**DURHAM CATHOLIC
DISTRICT SCHOOL BOARD**
Learning and Living in Faith

**T26-08 Universal Washroom Additions Two (2) Schools - St. James and St. John the
Evangelist Catholic School
Addendum No 2**

Addendum Date: Wednesday, April 22, 2026
Issued by: Purchasing Services
Durham Catholic District School Board

DATE: MAR 2026
SCALE: AS SHOWN
DRAWN BY: TD
CHECKED BY: MA
DWG STATUS:
PROJECT No.: 2025-504-1
DRAWING No.: M3.0-A-2 REVISION

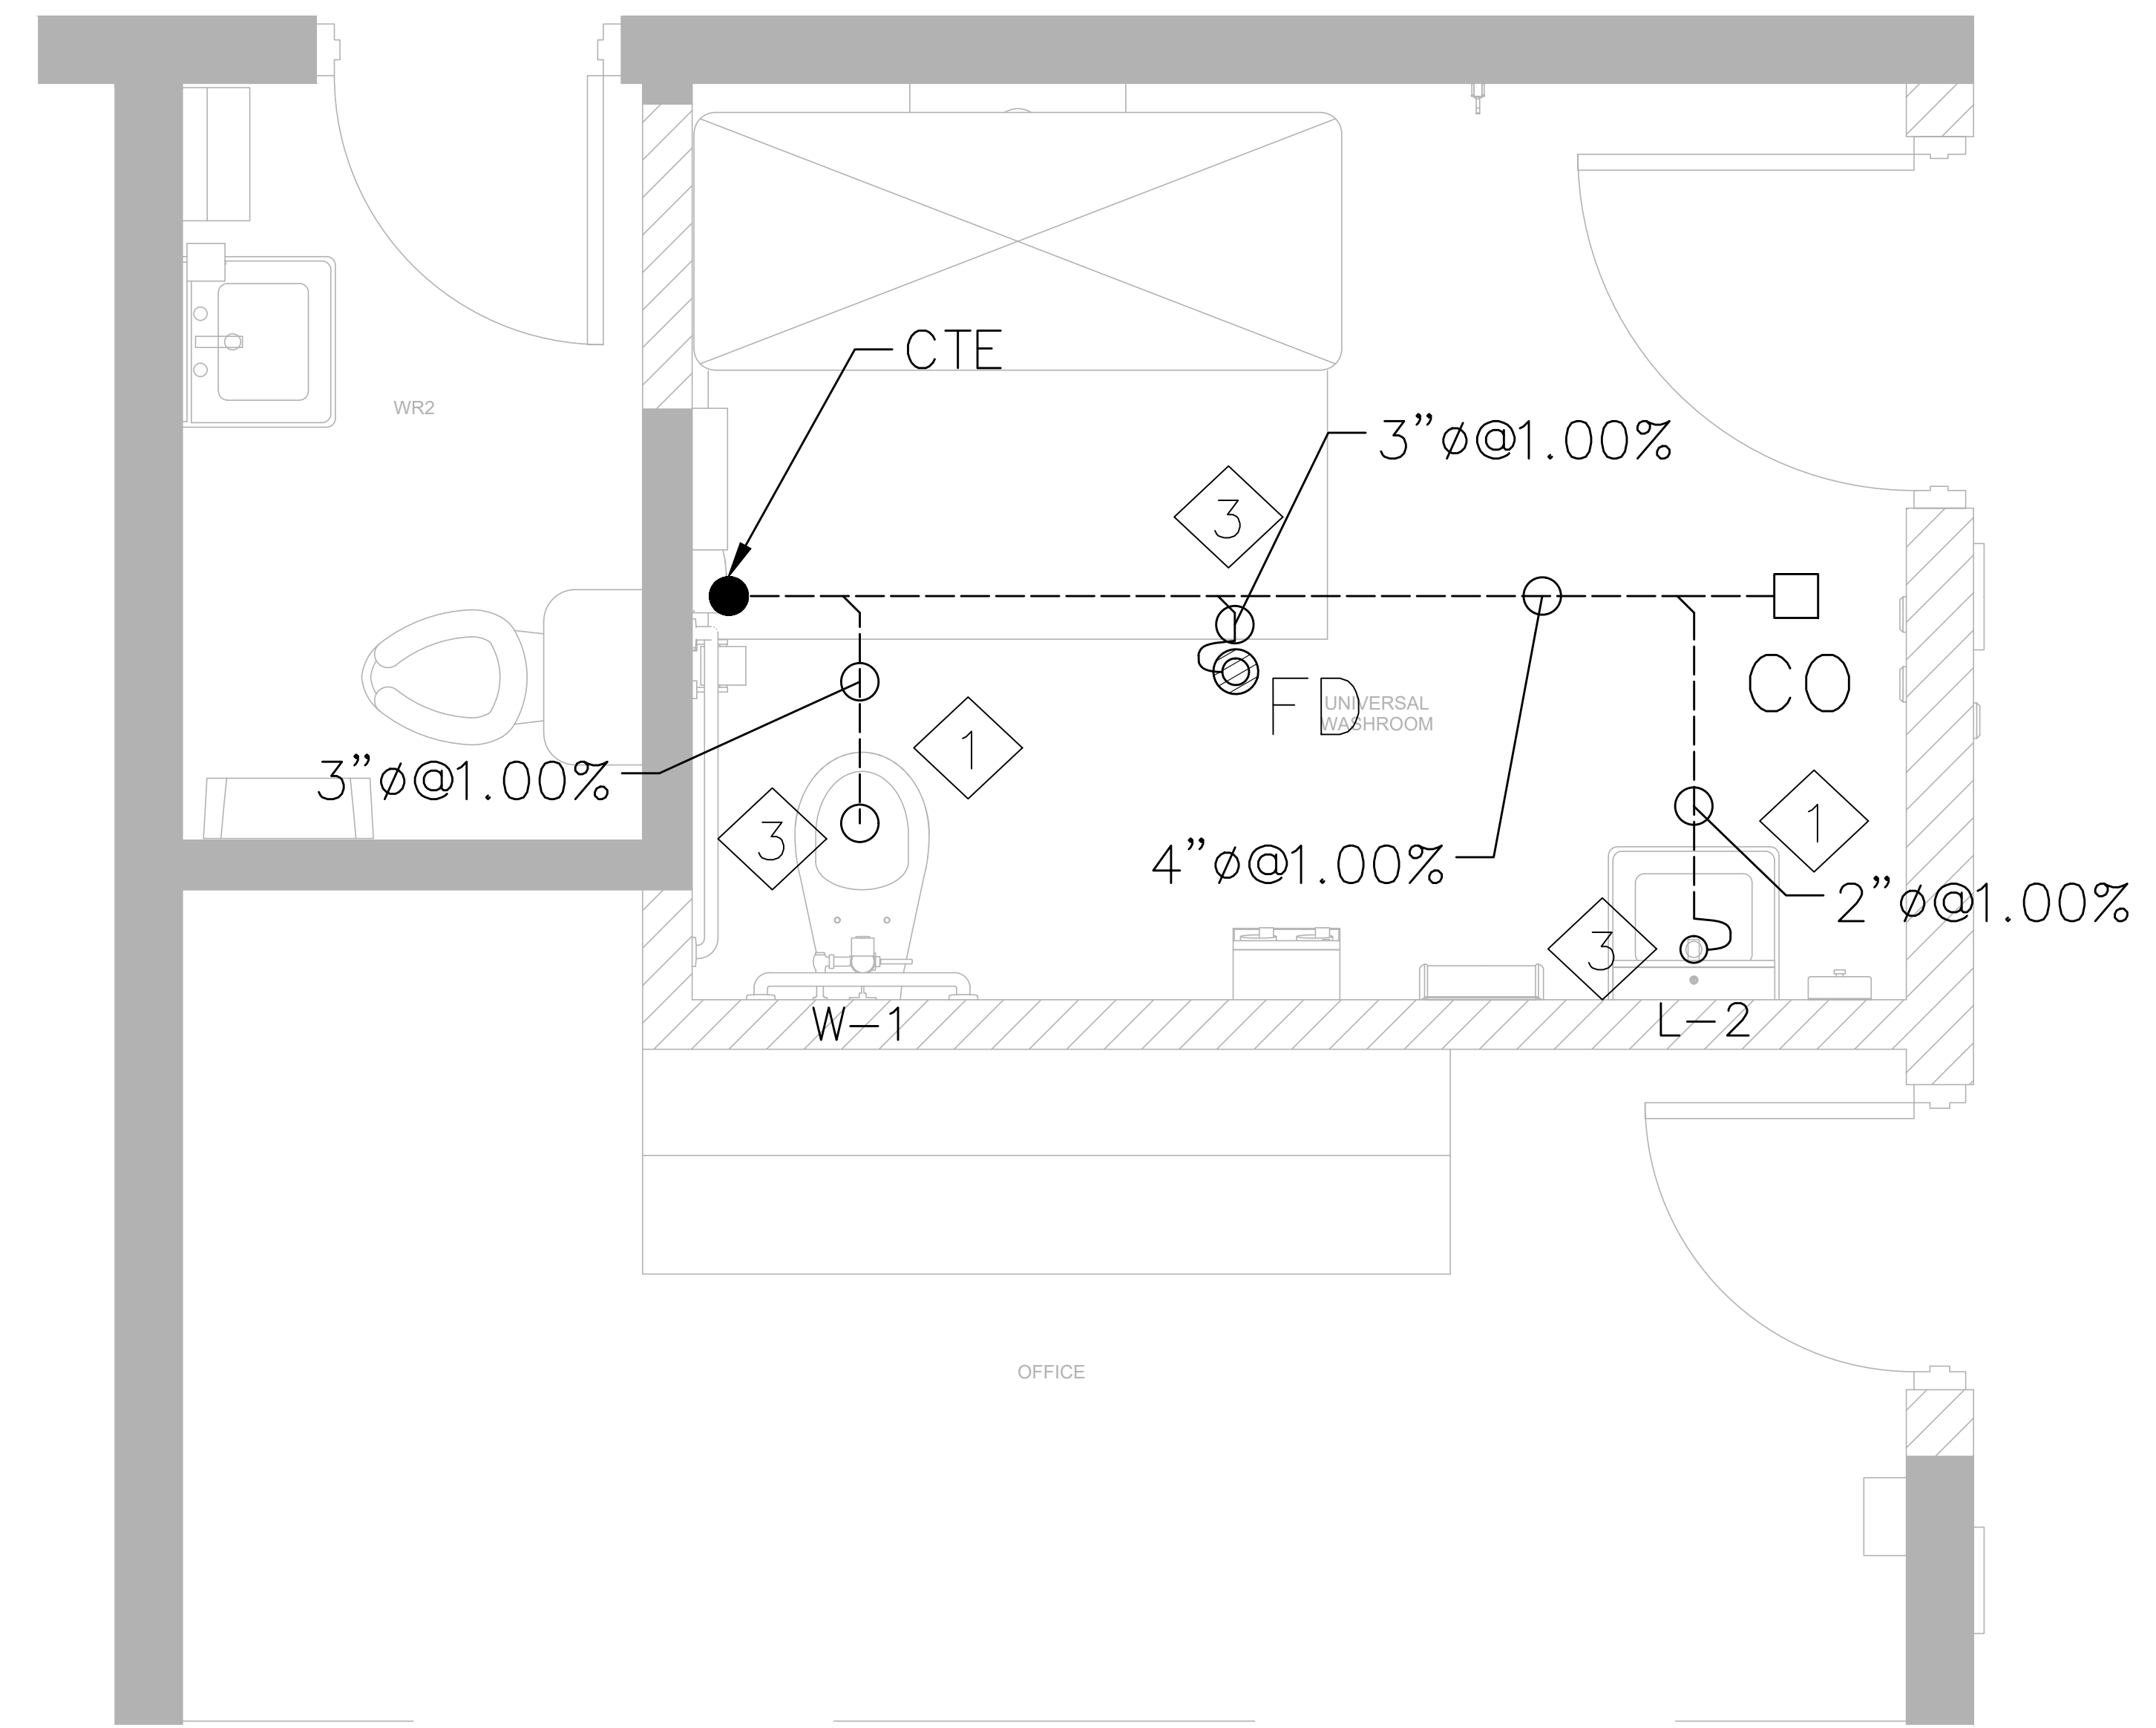
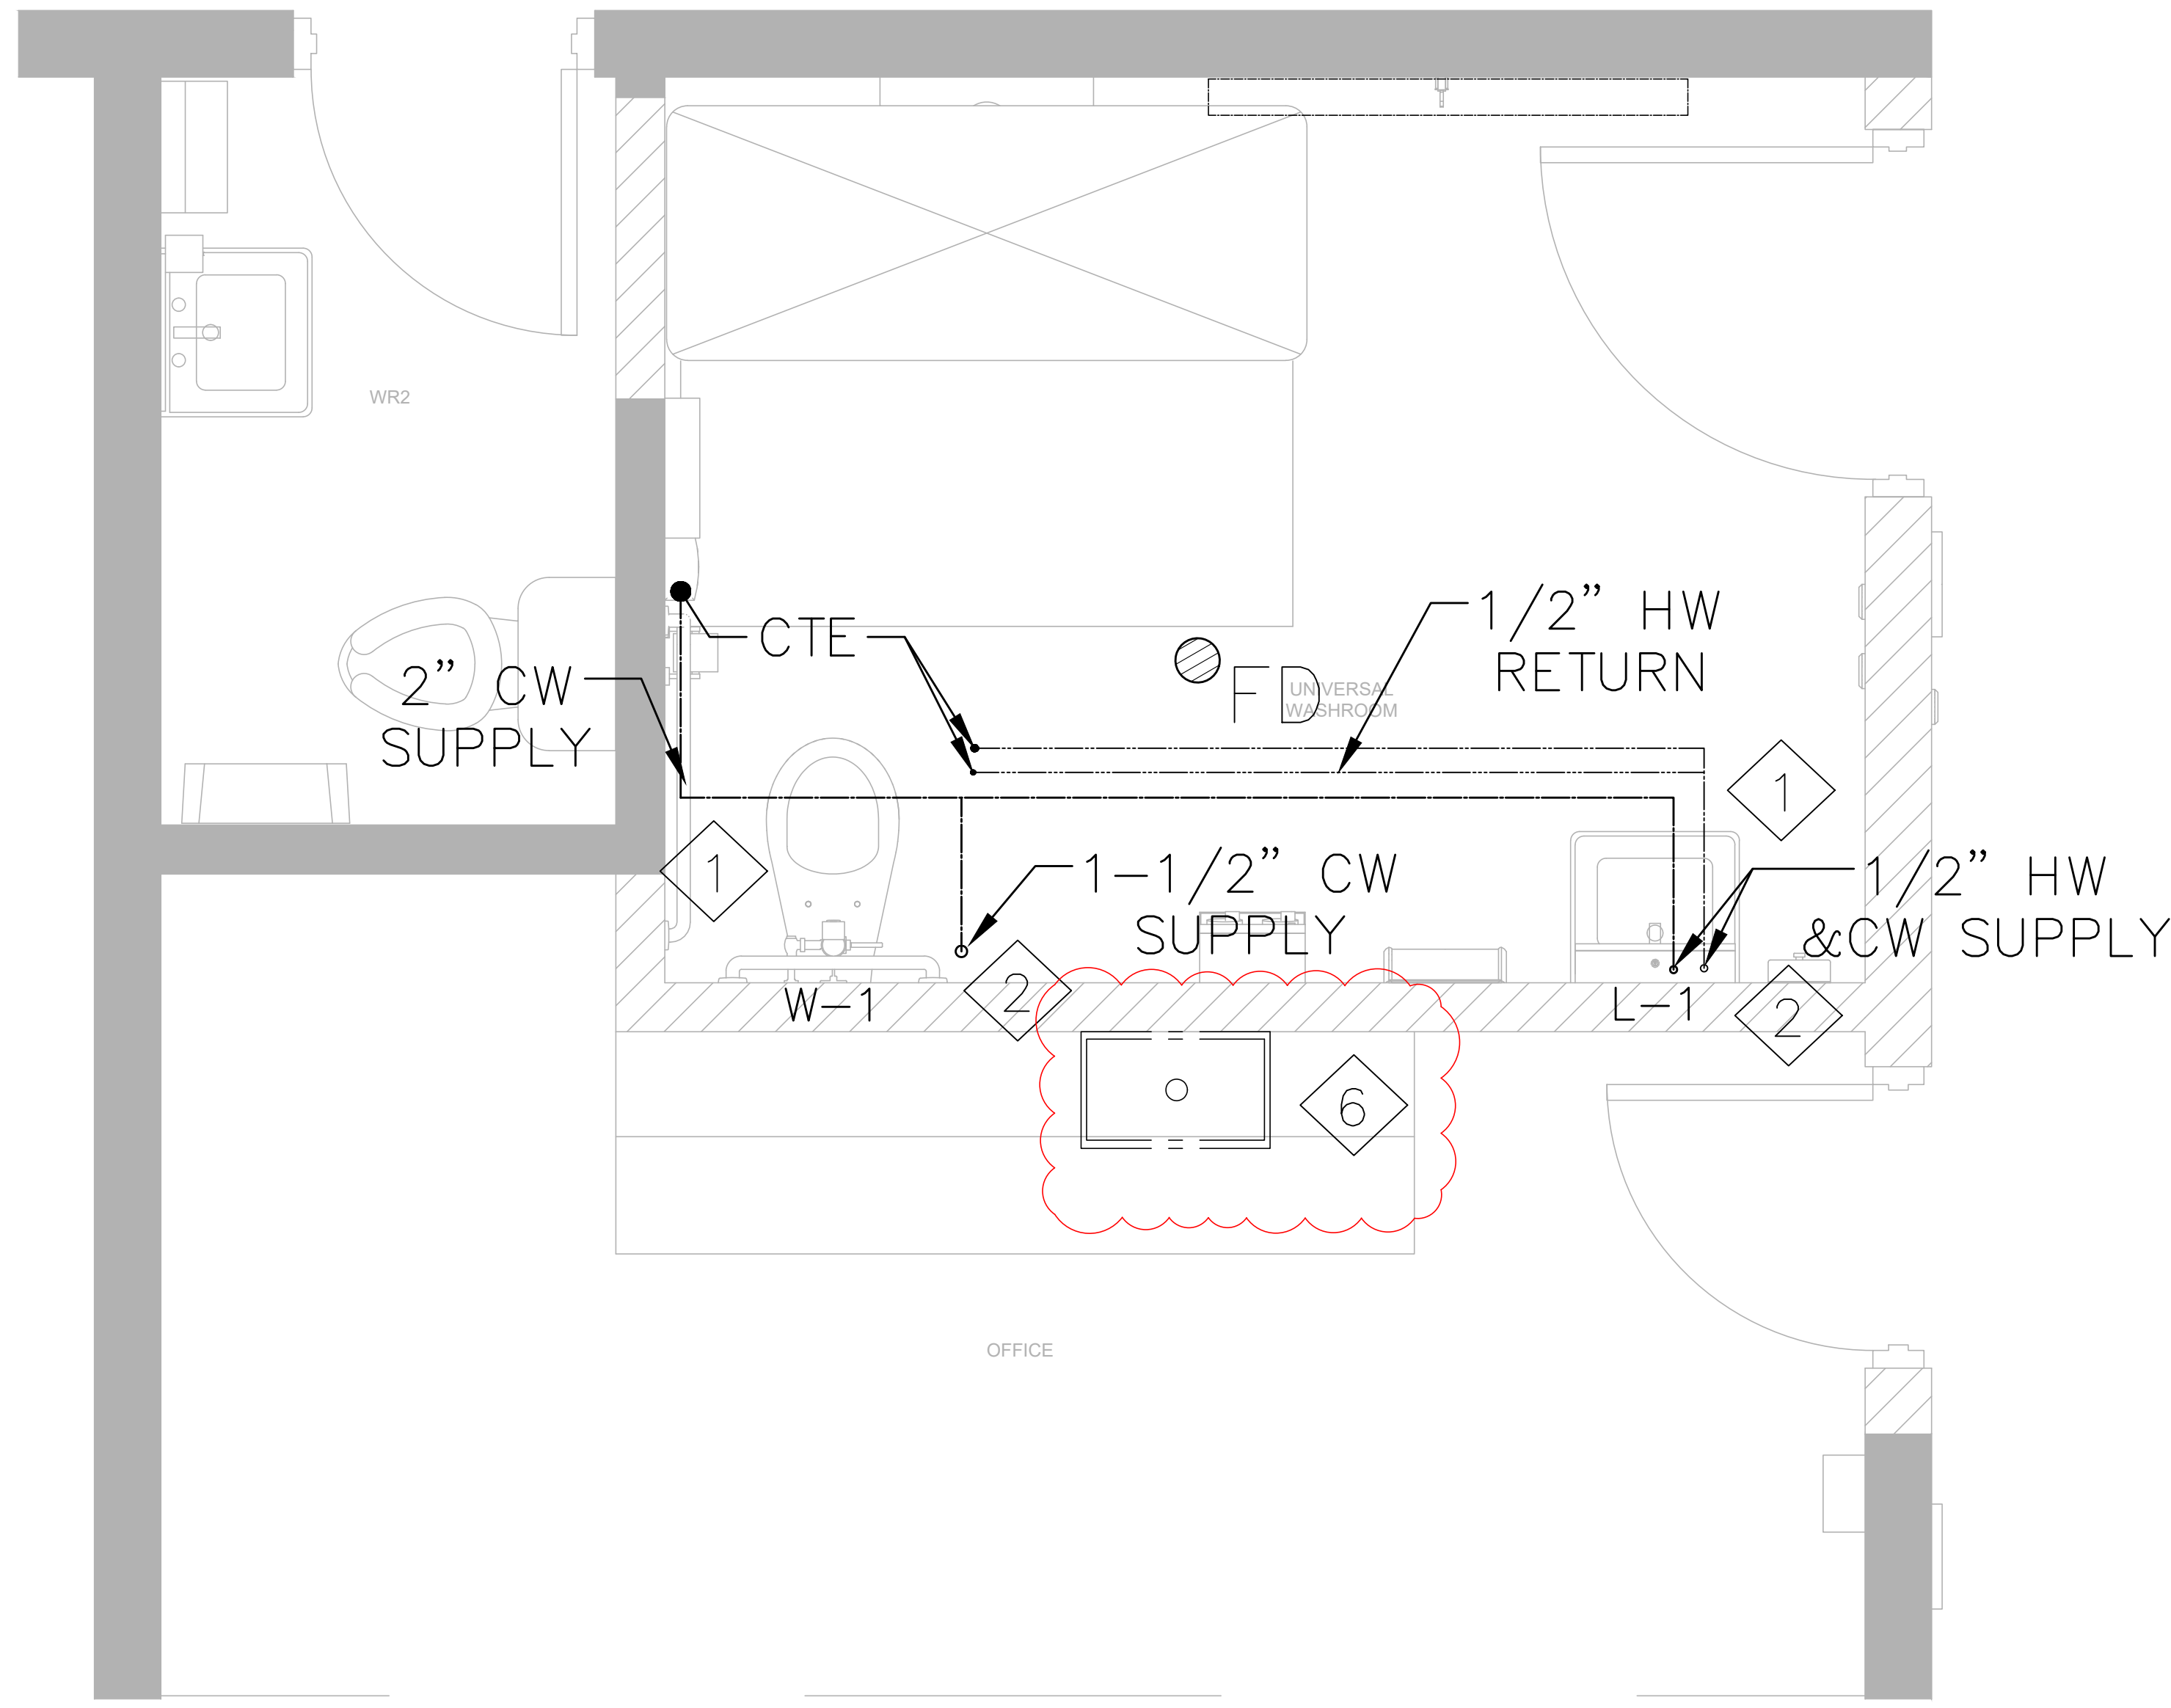
Is the expectation for existing concrete slab but be completely cut and removed within the new washrooms or only as required to complete plumbing scope? Both Locations

Please note that the mechanical contractor must perform a floor scan to find the exact location of the existing underground sanitary lines and is only required to cut and remove the existing concrete slab as necessary to complete the plumbing scope. Refer to mechanical dwgs

- 4 CONTRACTOR TO PROVIDE 3"Ø VENT PIPE RISER TO THE CEILING SPACE AND CONNECT TO THE EXISTING VENTING SYSTEM AS PER OBC AND LOCAL AHJ.
- 5 MECHANICAL TRADE TO SCAN THE FLOOR TO FIND THE EXACT LOCATION OF THE UNDERGROUND EXISTING SANITARY LINE. CONNECT THE NEW SANITARY LINE TO THE EXISTING. THE CONTRACTOR TO CUT AND REMOVE THE CONCRETE SLAB AS REQUIRED TO COMPLETE THE PLUMBING SCOPE.
